DAY TERRACE

LOT GRADING REVIEW

LOT/BLK. NO(S) Lot 93

LECCO RIDGE DEVELOPMENTS INC.

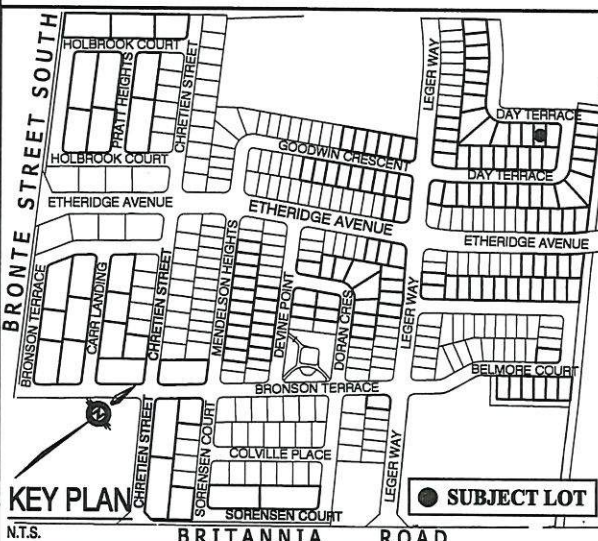
SUMP PUMP TO
DISCHARGE TO FRONT
SPLASH PAD.

45 MINUTE RATED WALL
WITH SIDE YARD < 1.2m
